Dublin Cycling Campaign

26th March 2024

## MetroLink Oral Hearing

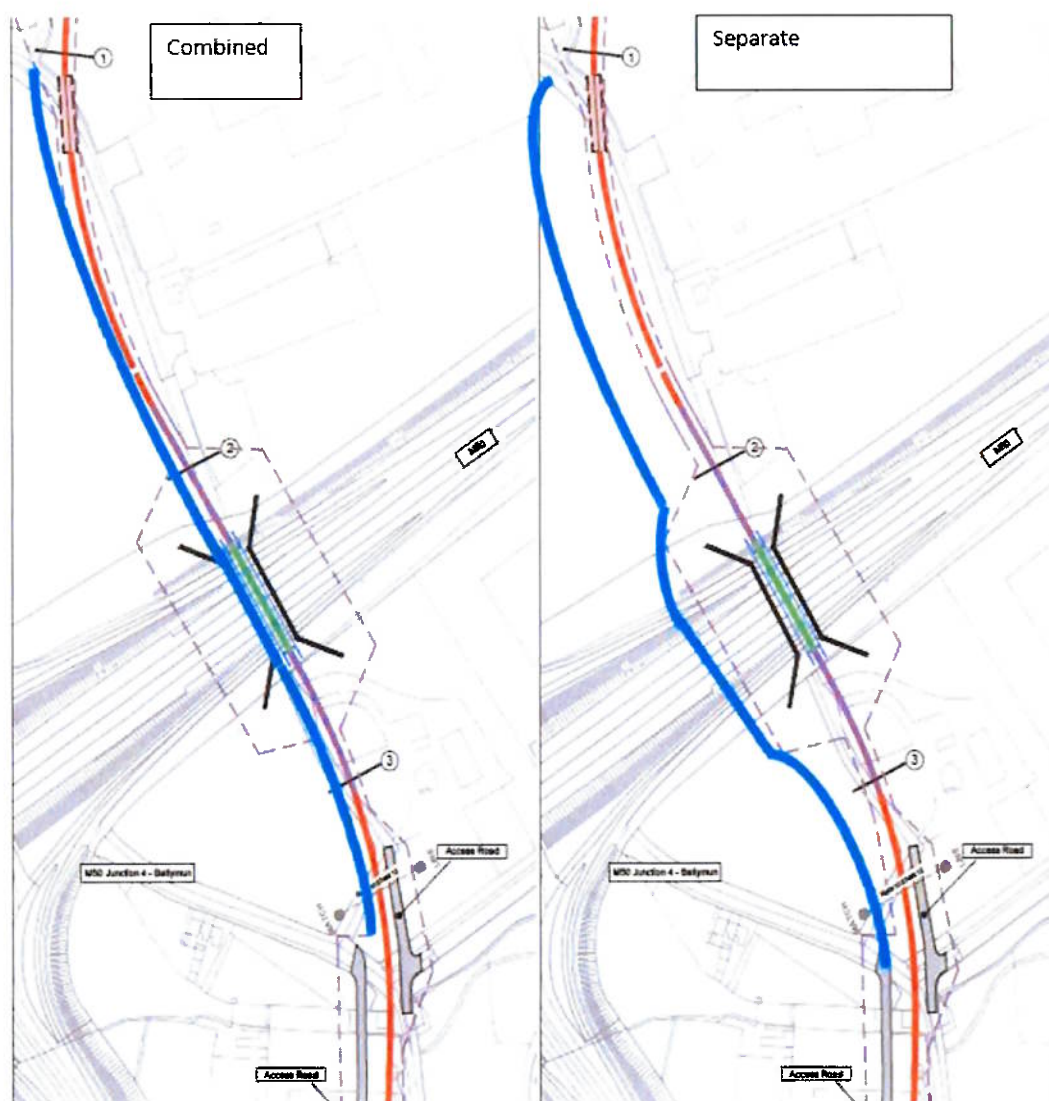
1. If the bridge was both feasible and recommended, why was this proposal for integrating active travel into the project dropped from the planning application?
2. Does the lack of an active travel bridge over the M50 at this location impact on the future sustainable development of the Daristown lands zoned for 'High Technology' or 'General Employment'?

Proposals considered are a combined Bridge to include for an additional 6m consisting of a 2 way cycleway and pedestrian link or a separate bridge as per Image 1 below:

Provide a separate 2 way cycleway and 2 way footpath bridge to the west of the existing bridge, of an overall width of at least 6m.

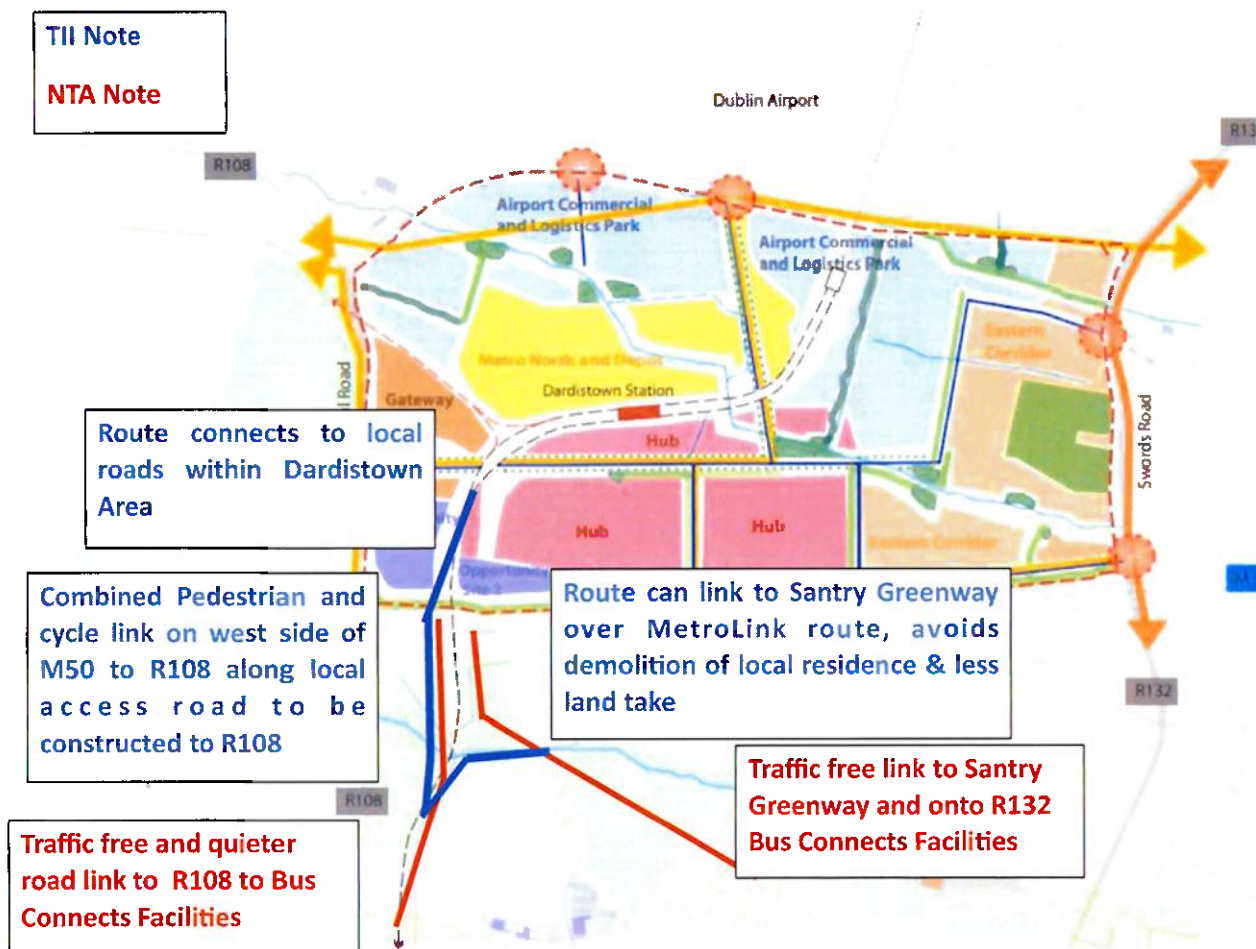
2) The provision of cycle and pedestrian facilities on the proposed metro link bridge would provide the basis of an alternative routing for pedestrian and cyclists to the R108 and R108/M50 junction. This is currently a hostile cycling and walking environment. Southbound cyclists and pedestrian have to share a substandard 2m wide path. Improving this would likely involve widening the gyratory over the M50. Refer to sketch below.

- 3) If cycling and pedestrian facilities could be provided on the bridge it would provide options for cycle and pedestrian networks for the Dardistown area that could reduce a severance effect, if any, of the Metro in the area, allow for more flexible development solutions on either side of the metro alignment and future proof against changing land uses.

**TII Response: A separate bridge will achieve this requirement.**

**TII Response:** See notes on image above. A separate bridge will achieve these objectives, accommodate future proofing with less overall land take and severance.
